SERVICE BULLETIN

ENGINE - OIL - INCORPORATE LONGER BOLTS TO ATTACH NO.4 BEARING COMPARTMENT SCAVENGE VALVE - CATEGORY CODE 5 - MOD.ENG-79-0018

V2500-ENG-79-0018

Replacement of the No.4 Bearing Compartment Scavenge Valve Attaching Bolts
Fig.1

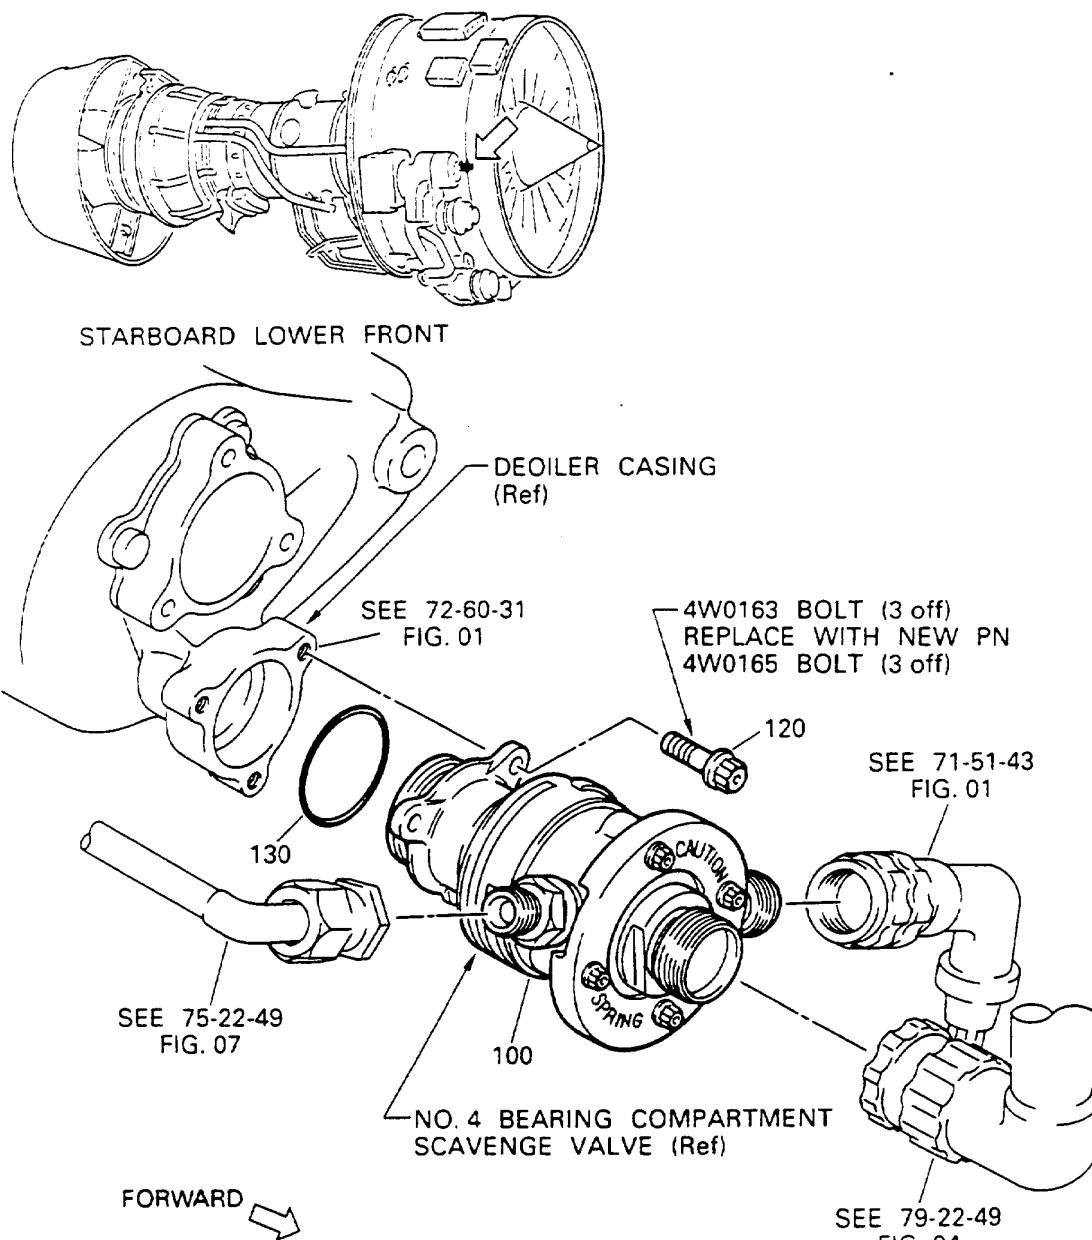
The bolts which attach the No.4 Bearing Compartment Scavenge Valve may not completely engage the tapped holes in the Deoiler casing flange.

(a) The existing bolts which attach the No.4 Bearing Compartment Scavenge valve have been changed to longer bolts (See Figure 1).

- (1) Replace the three bolts which attach the No.4 Bearing Compartment Scavenge Valve, one by one with the following steps (a) to (c) (Refer to Figure 1 and 1.K.(2)).
 - (a) Remove 4W0163, Bolt, from the No.4 Bearing Compartment Scavenge Valve and the Deoiler Casing.
 - (b) Install new 4W0165, Bolt, to the No.4 Bearing Compartment Scavenge Valve and the Deoiler Casing.
 - (c) Torque the Bolt, to 85 - 105 lbfin (10,00 - 12,00 Nm).
